## PUBLIC ARTS ADVISORY BOARD STAFF REPORT

1880 Dr. Andre's Way

Meeting	File No.	Application Type
February 25, 2025	2025-051 (Bldg. 1880 Façade 4)	1 Mural Permit Application
Property Owner	Applicant /Agent

Consideration of the installation of 1 mural on west elevation of Building 1880 located at 1880 Dr. Andre's Way.

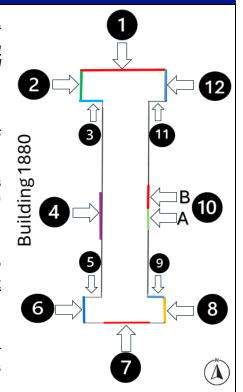
The mural on Façade 4 is a large abstract artwork measuring 12 feet high by 35.5 feet wide (426 sq. ft.), covering 100% of the west elevation of Building 1880. It features a blend of colors primarily in yellow, golden, white, and brown hues, creating a dynamic and vibrant appearance with the text "The Rose Delray" prominently displayed in a bold red and black letters. The upper portion of the mural resembles clouds or a heavenly scene, characterized by its lighter tones and ethereal quality. In contrast, the lower section depicts a cracked faux wall, utilizing dark shades of brown and yellow, adding depth and texture to the composition. The transition between the two areas suggests a movement from a grounded, earthly element to a more celestial or heavenly atmosphere. The entrance of the tenant business - Rose Marcom LLC, a full-service marketing and communications company – depicts a red detailed rose above with black rounded vertical strips that tapers off in the background.

While the mural meets the general definition of public art per Appendix A of the LDRs, its integration with commercial messaging raises concerns regarding compliance with LDR Section 8.5.3(C)(4), the mural shall be predominantly pictorial, with text limited to no more than 5 percent of the proposed mural size, except for text used to create the graphic. The "The Rose Delray" text functions as identification signage rather than an artistic component, however, maintaining the 5% text limit established for murals. According to LDR

Sign Code Section 4.6.7, text within murals that serves a commercial or branding function is classified as a wall sign, requiring a separate sign permit. In this case, the mural blurs the line between artistic expression and business advertising, making it non-compliant with the mural regulations without a sign waiver.

From a design perspective, the composition is visually simplistic, relying heavily on shapes, colors, lines, and textures to create a composition. The proposed mural raises concerns about long-term maintenance. Without clear maintenance commitments, the artwork risks degrading guickly, impacting its overall effectiveness as a public art feature.

While the mural partially meets LDR requirements for coverage, placement, and façade integration, its commercial branding, and maintenance concerns present significant compliance issues. Although use of text does not exceed allowable limits, the content of the text functions as a commercial sign rather than integrated as part of the mural. This raises the question of whether the mural genuinely enhances the district's creative vision or simply serves as a stylized branding tool for the development.
